**Staff Analysis of Proposed Amendment to the
Dane County Water Quality Plan,
Revising the Sewer Service Area Boundary and Environmental Corridors
in the Cottage Grove Urban Service Area**

Attachment 2 – Public Comment Letter Received and Village Response

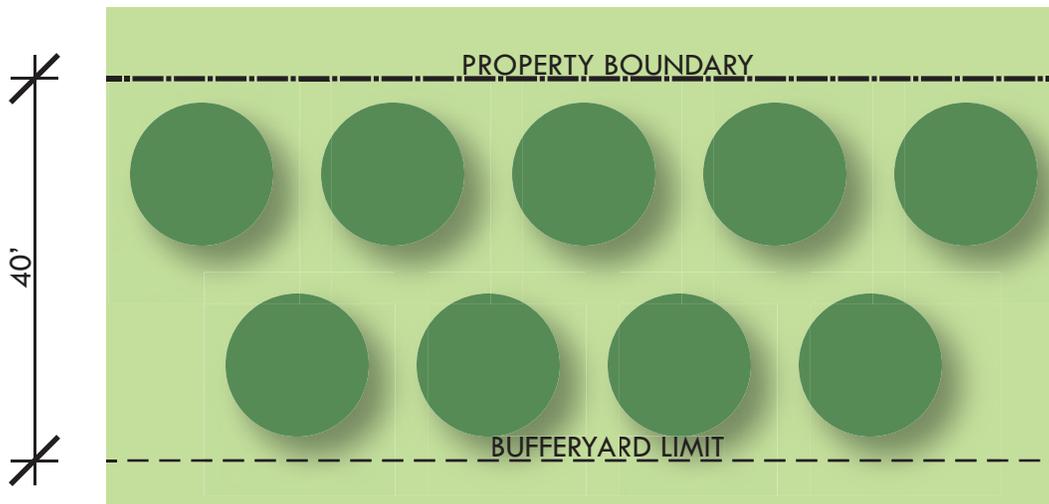
Maintain compliance with NR151 for a 90% stay-on. The stated Infiltration performance standard in section 5.9 (4) states "Requirement for both residential and nonresidential developments to infiltrate sufficient runoff volume so that post development infiltration volume shall be at least 90% of the predevelopment infiltration volume based on the average annual rainfall."

- 1.) All developments, regardless of impervious -> target = 90% predevelopment infiltration
- 2.) Exemptions (infiltration not required):
 - a. Parking areas and access roads less than 5,000 square feet for commercial & industrial development
 - b. New development sites with less than 10% connected imperviousness and <1 acre total impervious
 - c. Redevelopment sites.
 - d. Areas where the measured infiltration rate is less than 0.6 in/hr
 - e. Roads in commercial, industrial, and institutional land uses, and arterial residential roads.
- 3.) Prohibitions (infiltration not allowed):

- a. Areas associated with a tier 1 industrial facility
- b. Storage and loading areas of a tier 2 industrial facility
- c. Fueling and vehicle maintenance areas.
- d. Areas of Karst bedrock (direct conduits to groundwater)
- e. Areas where there is inadequate separation distance (depth) to groundwater or bedrock
- f. Areas within a certain distance of a well
- g. Areas where there is soil contamination

Based on our engineer's review it appears that the Dane County and Village ordinances offer fewer exceptions for infiltration than NR 151, not more.

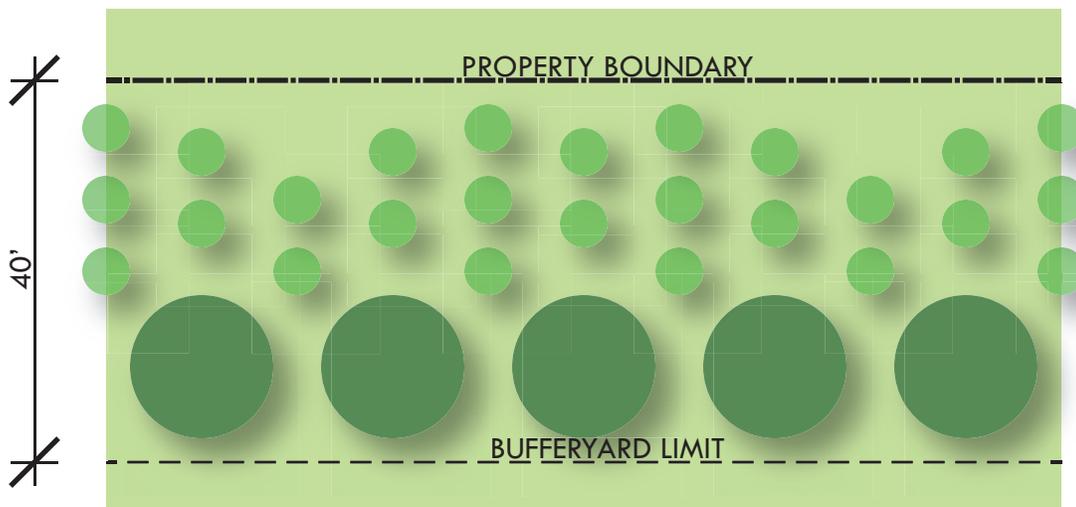
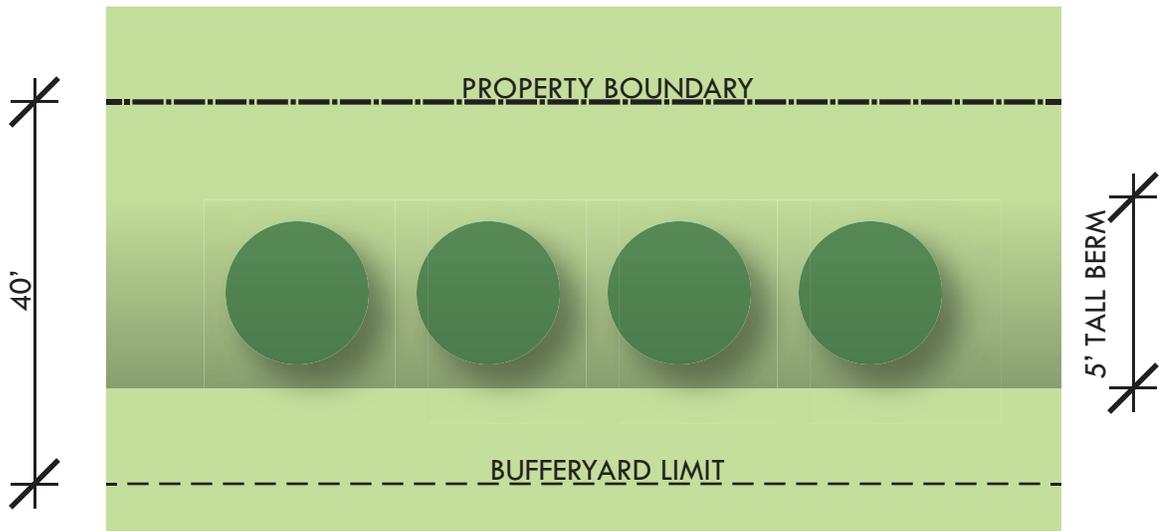
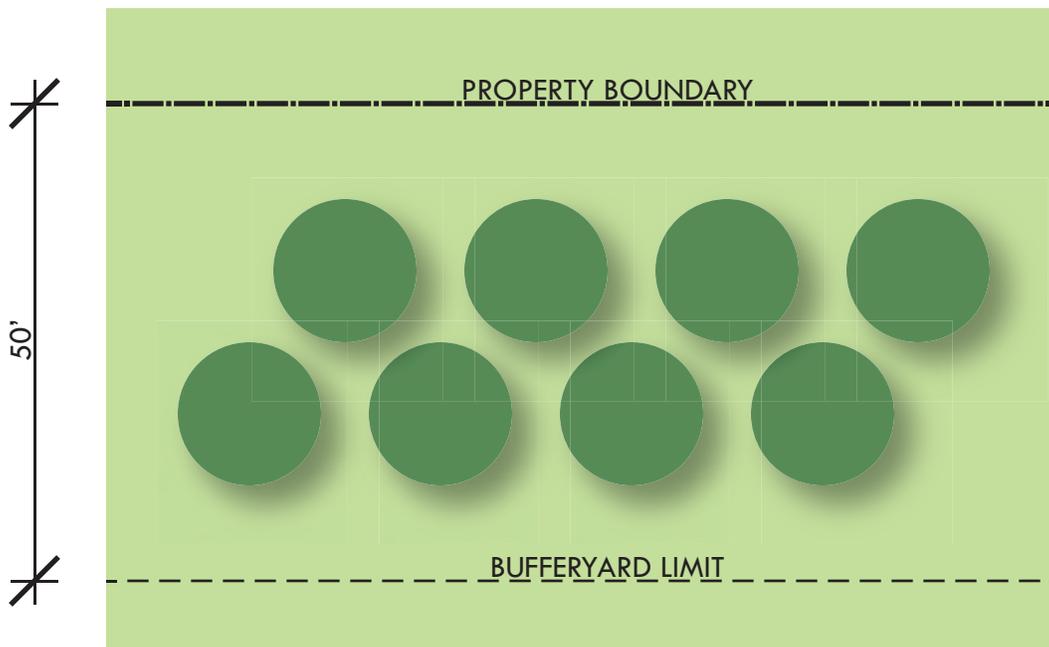
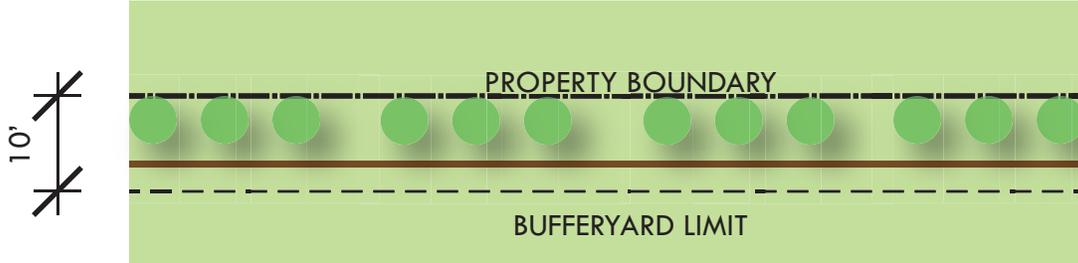
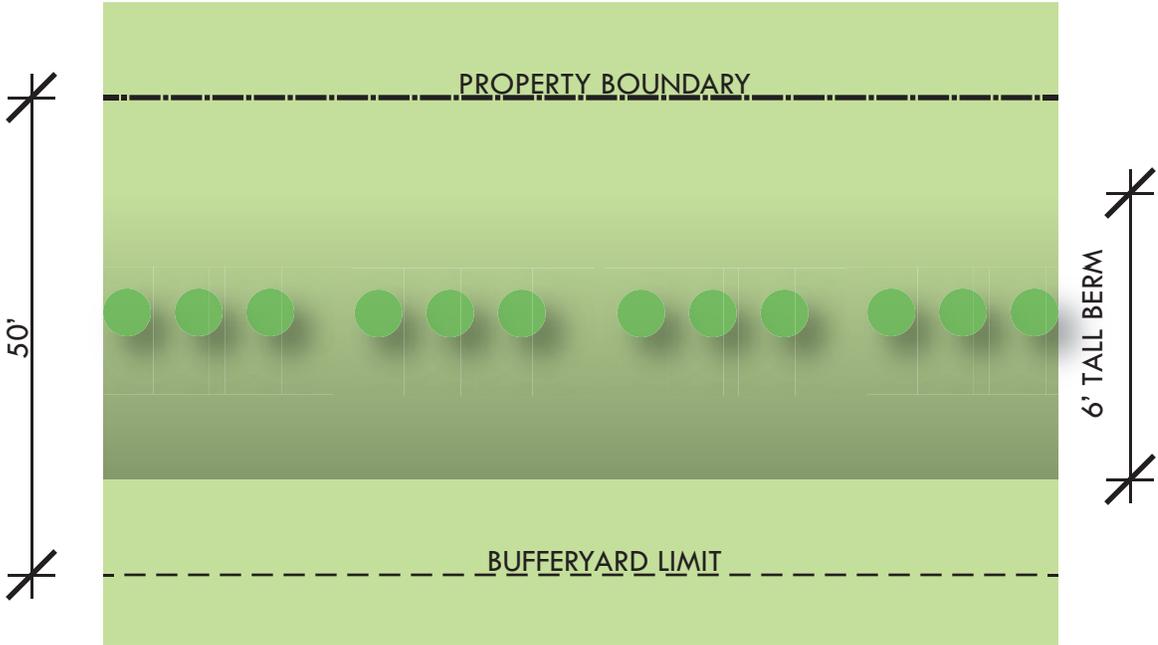
Maintain a 75-foot buffer, between the current Town residential parcels and the new intensive Village development. This would provide visual, stormwater and acoustic separation for the existing residential properties. The Village responded that they have a complex buffering ordinance and they would provide examples of how their standards would apply. To date we have not received these examples, so we remain concerned about the proximity of the development.

Landscaped bufferyards are required by Village Ordinance along boundaries where different zoning districts meet, per [Table 325-62\(D\)\(1\)](#). The adjacency that the Town is concerned about would be the abutting of new office/light industrial land uses to an existing Town single-family residential subdivision. The most likely zoning district for the office/light industrial area is PI, Planned Industrial. The most similar Village zoning district to the Town land use would be SR-4, Single-Family Residential.

While the Town requested a 75' wide buffer, the Village feels that a landscaped buffer meeting the ordinance would likely provide a more effective buffer than a simple 75' width with no landscaping.
